PROJECT: LOMALAND PHASE IV, SOUTHEAST AREA, EL PASO, TEXAS

1. This is Amendment No. 6 to Solicitation No. DACW47-02-B-0011; 08 April 2002. The following revisions shall be incorporated into the specifications. All other provisions shall remain unchanged.

DACW47-02-B-0011
Amendment No. 6

FEATHERLAKE BASIN

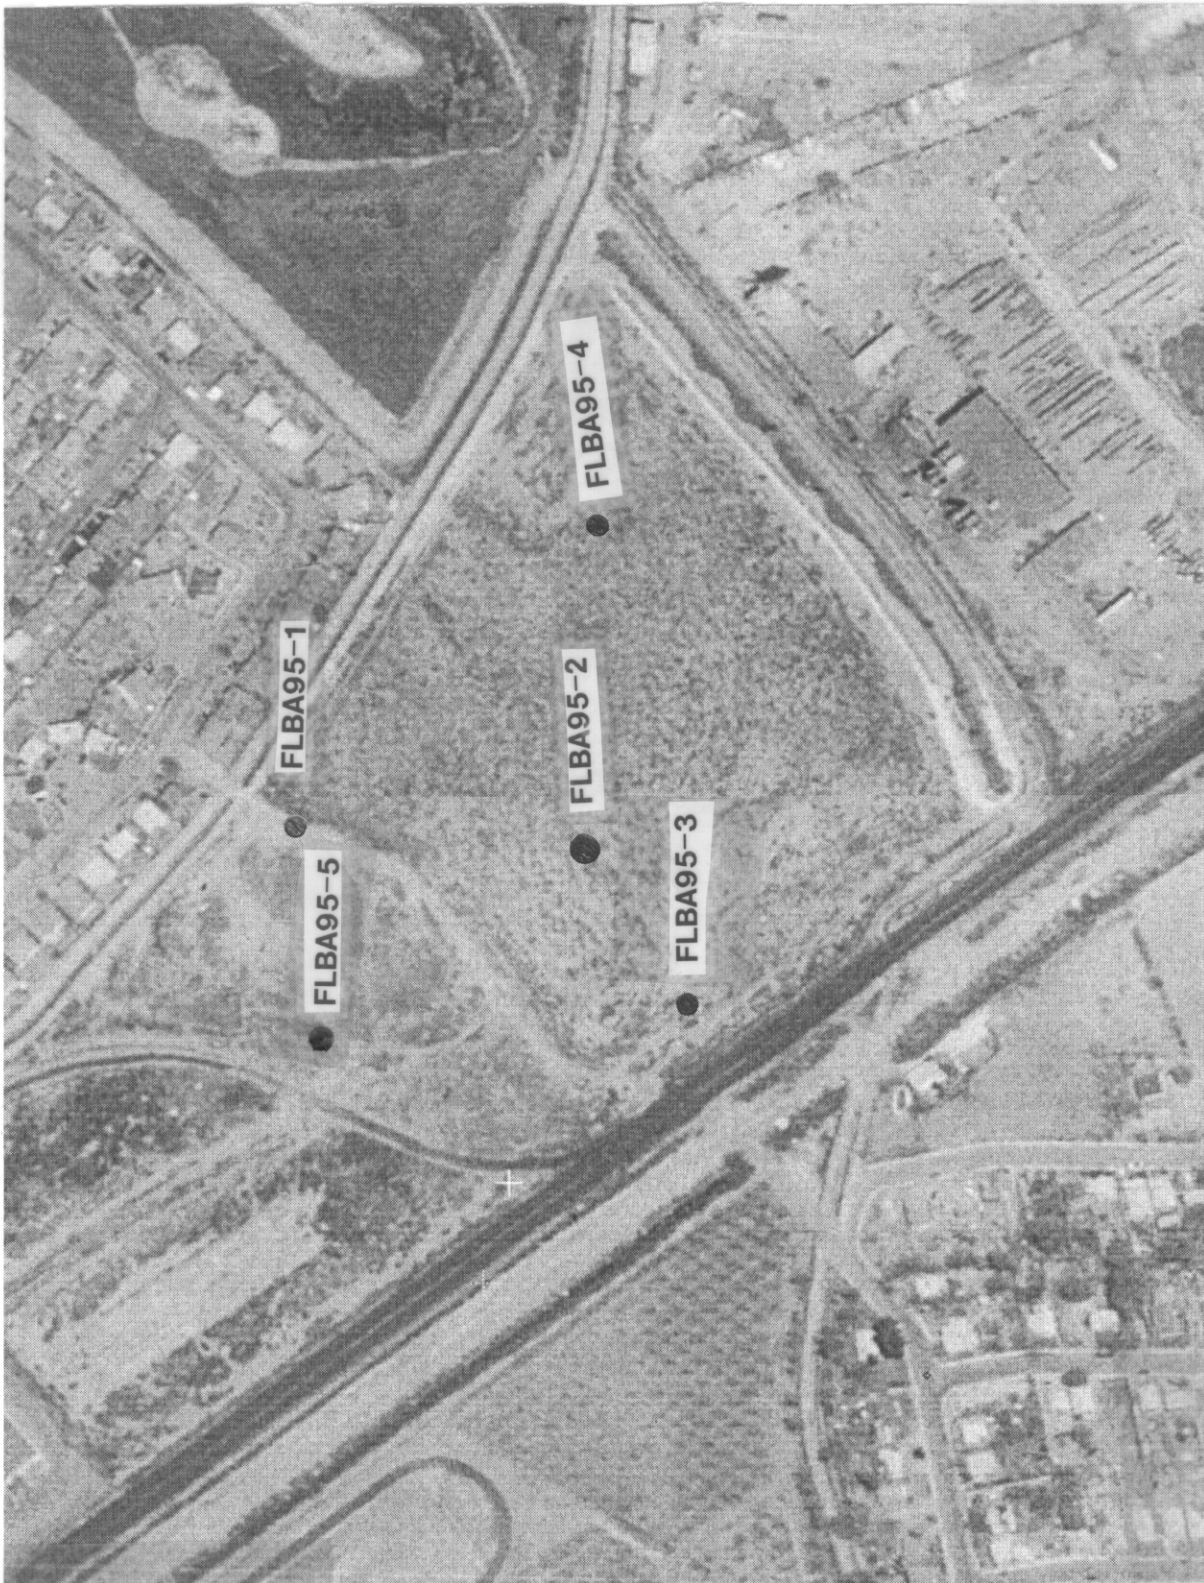
b. After Boring Log Hole No. SE95-45, add the drawing of "Featherlake Basin" and Boring Logs Hole No. FLBA95-1 thru FLBA95-5, attached hereto.
